In the Matter of the Application of AEP Ohio Transmission Company, Inc. for an Amendment to the Certificate of Environmental Compatibility and Public Need for the Macksburg-Devola 138 kV Transmission Line Project

Application for Amendment

Macksburg-Devola 138 kV Transmission Line Project

OPSB Case No. 19-1069-EL-BTA

Exhibit 11. Map Illustration of Engineering Adjustment (Structures 78 through 79)

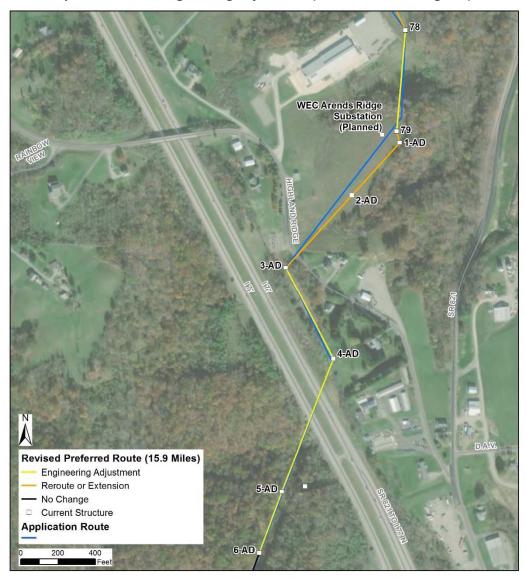
Engineering Adjustment 10 is located along the Macksburg to Arends Ridge section from Structure 78 to Structure 79 (Exhibit 11). This adjustment was made to connect the Preferred Route to the finalized location for the Arends Ridge Substation.

Exhibit 13. Map Illustration of Reroute 2 (Structures 25 through 27)

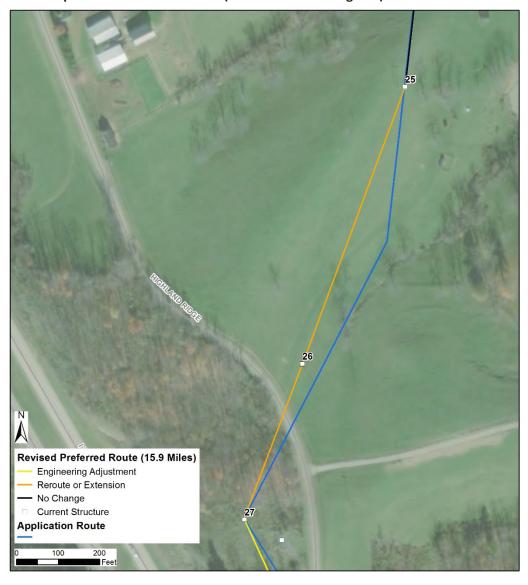
Reroute 2 is located in the northern portion of the Macksburg to Arends Ridge section. This reroute, as shown in Exhibit 13 below, is due to eliminating an extra transmission line structure on the landowner's property thereby requiring Structure 26 to shift west approximately 50 feet. The application route paralleled an existing distribution line for a portion of this segment. This reroute would result in less than 0.1 acre of additional tree clearing.

Exhibit 16. Map Illustration of Reroute 5 (Structures 75 through 78)

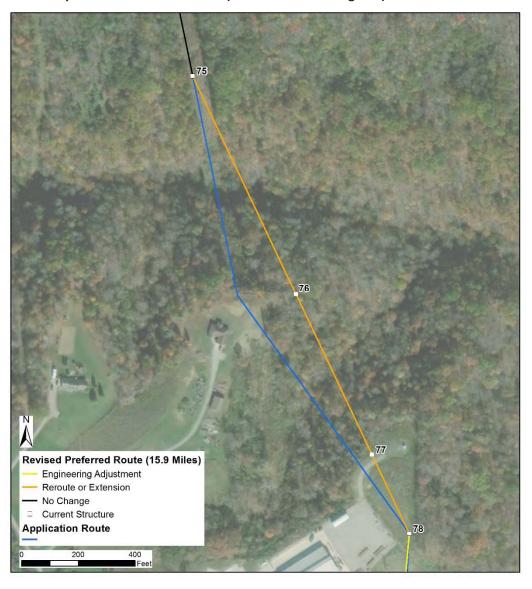
Reroute 5 is located at the southern end of the Macksburg to Arends Ridge section. This reroute, as shown in Exhibit 16 below, is due to the property owner's request which resulted in shifting the location of Structure 76 and the alignment approximately 200 feet east. This reroute would result in an additional 1.0 acre of tree clearing.

Exhibit 17. Map Illustration of Reroute 6 (Structures 79 through 3-AD)

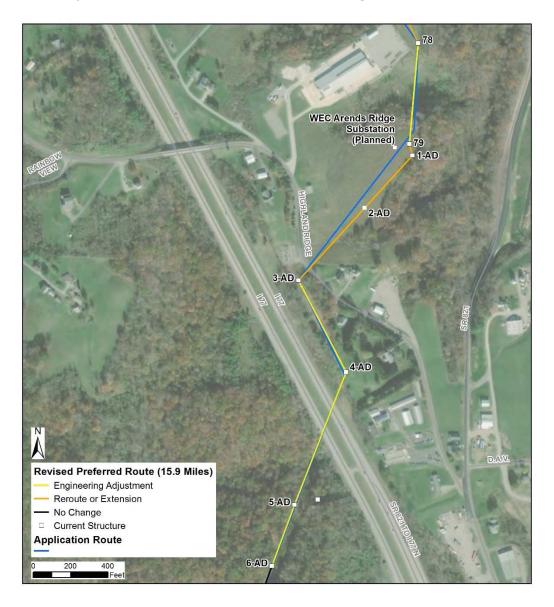
Reroute 6 is located at the northern end of the Arends Ridge to Devola section. This reroute, as shown in Exhibit 17 below, shifts the proposed route approximately 78 feet to the east based on the final location of the planned Arends Ridge Substation. This reroute results in an additional 0.2 acre of tree clearing.

Exhibit 18. Map Illustration of Reroute 7 (Structures 25-AD through Arends Ridge - Devola Substation)

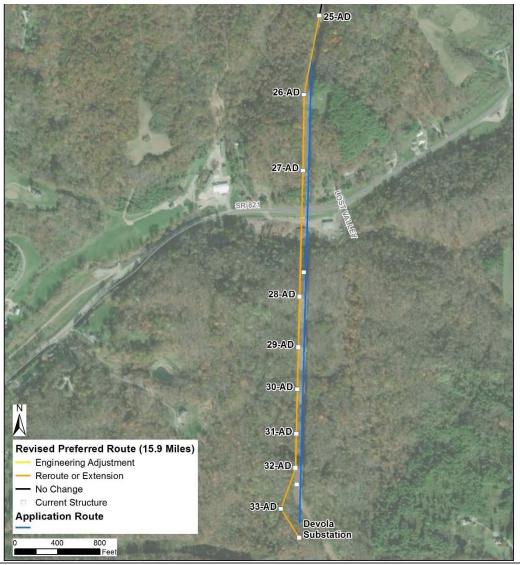
Reroute 7 is located along the Arends Ridge to Devola section. This reroute, as shown in Exhibit 18 below, is due to the Preferred Route alignment located too close to the existing overhead distribution which would require extended outages of the distribution line during construction. Shifting the alignment approximately 52 feet to the west would provide enough clearance to the existing distribution line that extended distribution outages would not be needed. This reroute would result in approximately1.5 acres of tree clearing.

Exhibit 19. Map Illustration of Reroute 8 (Structures 55 through 9-B)

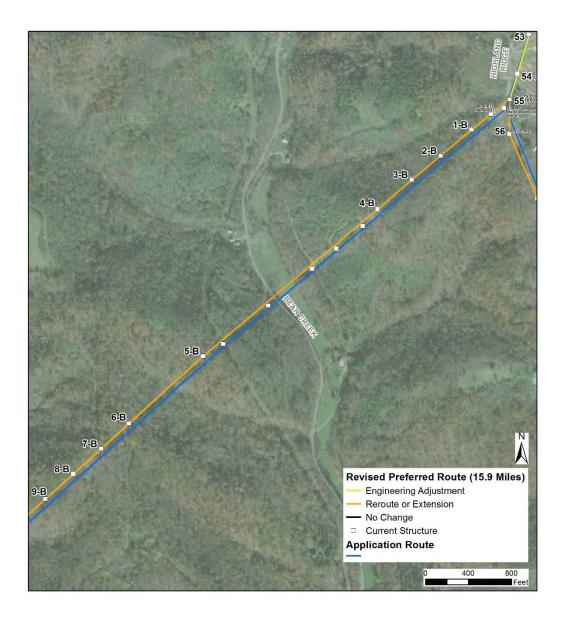
Reroute 8 is located along the Buell Extension. This reroute, as shown in Exhibits 19 and 20 below, is due to the need for adequate clearance between the Preferred Route alignment and the existing overhead distribution line, which would otherwise require extended outages of the distribution line during construction. The OPSB's staff also recommended a shift due to the number of riparian trees that would need to be cleared near Structure 4-B. Shifting the alignment approximately 60 feet to the west provides sufficient clearance from the existing distribution line, eliminates the need for a crossing of the existing distribution line, and reduces the impact to riparian trees. This reroute would result in an additional 1.9 acres of tree clearing.

Exhibit 21. Map Illustration of Reroute 9 (Structures 19-B through 22-B)

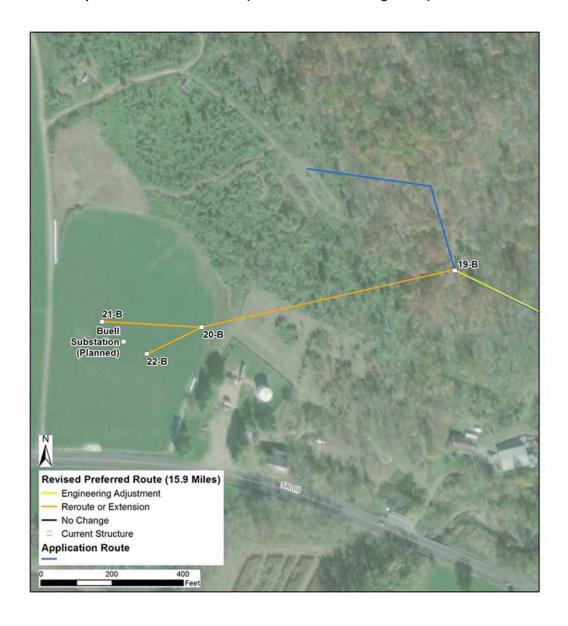
Reroute 9 is located at the southern endpoint of the Buell Extension. This reroute, as shown in Exhibit 21 below, extends the proposed route to the southwest for approximately 855 feet. This reroute is needed to connect the Preferred Route to the final location of the planned Buell Substation. This reroute would results in less than 0.2 acre of tree clearing.
